UNITED STATES PATENT AND TRADEMARK OFFICE

APPLICATION NO.	FILING DATE	FIRST NAMED INVENTOR	ATTORNEY DOCKET NO.	CONFIRMATION NO.
10/724,387	12/01/2003	John W. Rohan-Weaver	ROHAN-WEAVER Pure Swing	9659
7590	07/28/2004		EXAMINER LEGESSE, NINI F	
Julian C. Renfro, Esquire P.O. Box 2601 Winter Park, FL 32790-2601			ART UNIT 3711	PAPER NUMBER

Office Action Summary

DETAILED ACTION

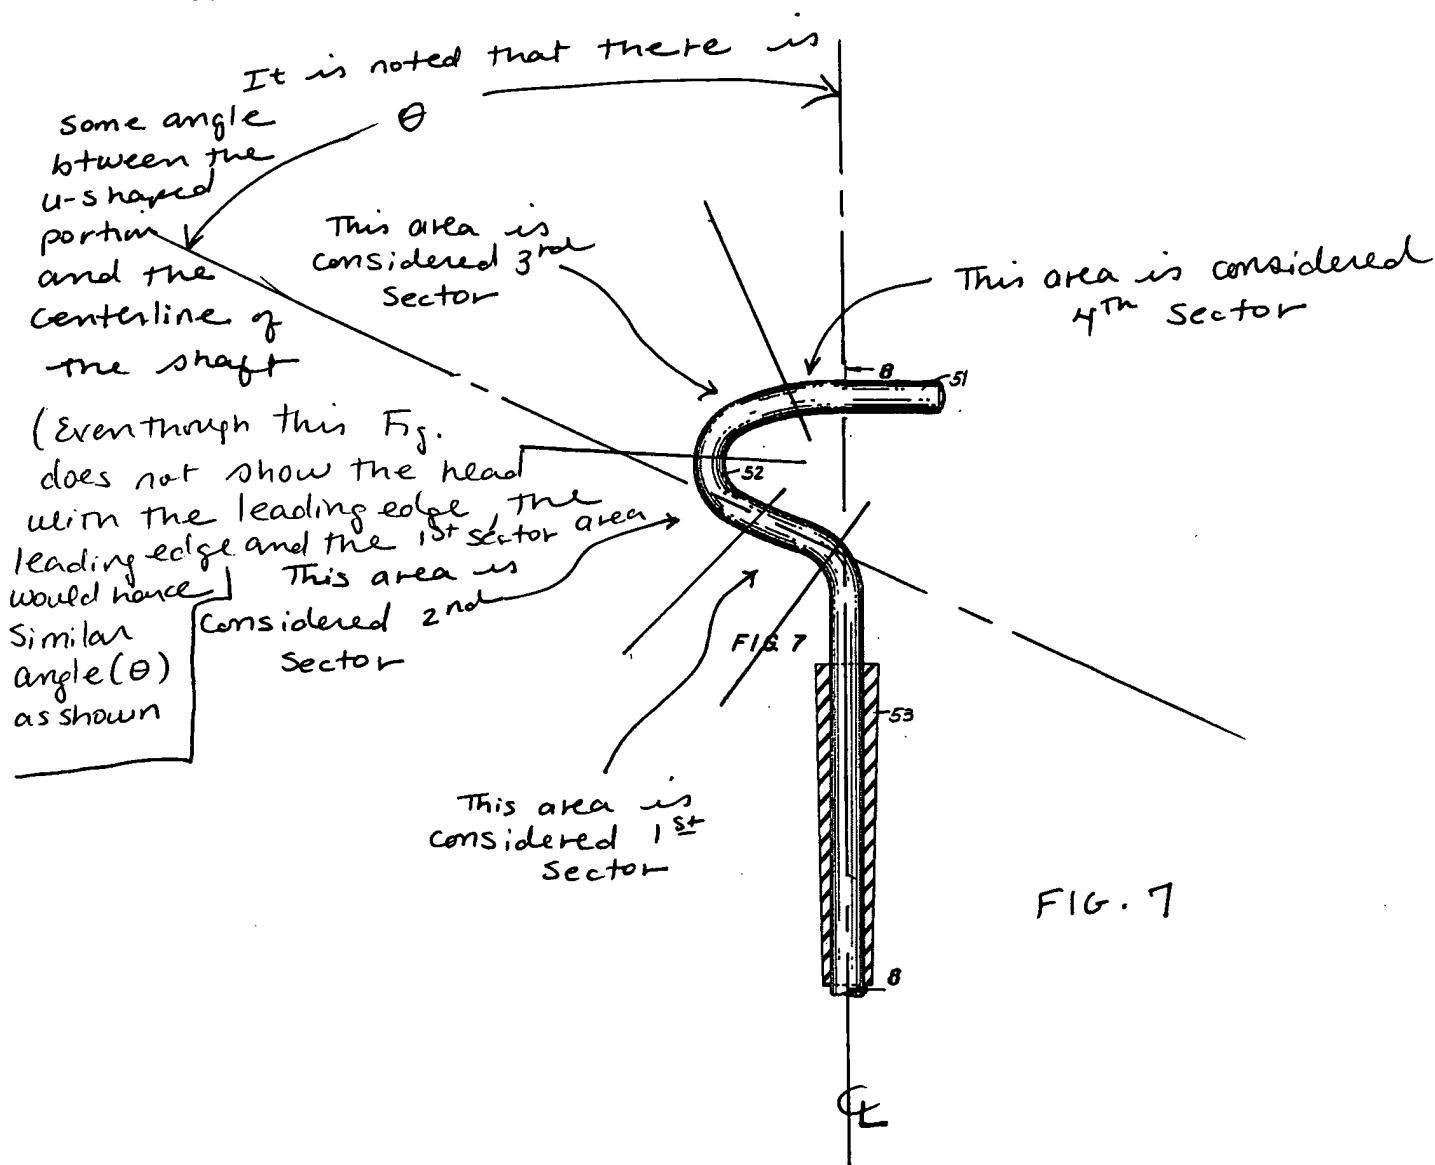
- **With respect to claims 3, 7 and 14**, the upstanding curved portion/U-shaped portion is made up of four separate sectors (see the marked up Figure provided below).

In order to clarify the Examiner's broad interpretation of the claims that are rejected by the Schneller (US Patent No. 5,127,650) reference, mark up drawing of Fig. 7 of this reference is presented below.
